**PROJECT:** NEW DORMITORY FOR THE DAUPHIN ISLAND SEA LAB CAMPUS  
FOR DAUPHIN ISLAND SEA LAB  
GMC PROJECT NO. AMOB230181

**RE:** ADDENDUM NO. 4 AND ACKNOWLEDGEMENT OF RECEIPT OF ADDENDUM NO. 4

ADDENDUM NUMBER 4

PROJECT: NEW DORMITORY FOR THE DAUPHIN ISLAND SEA LAB CAMPUS  
FOR DAUPHIN ISLAND SEA LAB  
GMC PROJECT NO. AMOB230181

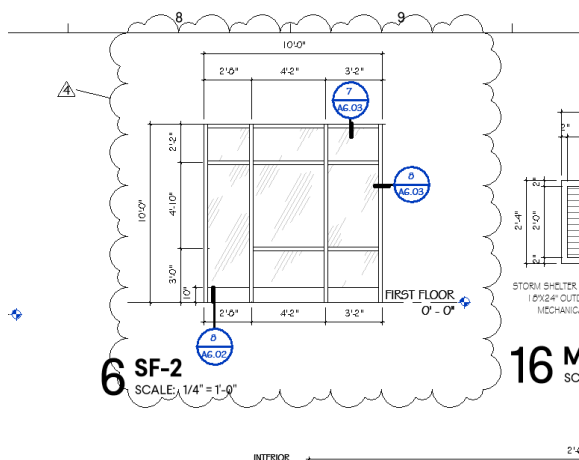
1. Bidders shall acknowledge receipt of the Addendum in writing, as provided on the Acknowledgment Receipt.
2. Per sheet A6.03, elevation "SF-2", vertical mullions must run continuous from head to sill in order for the opening to maintain its hurricane rating. Please advise.

**RESPONSE: The Sheet A6.03 SF-2 elevation has been revised to provide continuous vertical mullions to provide a hurricane impact rated storefront system.**
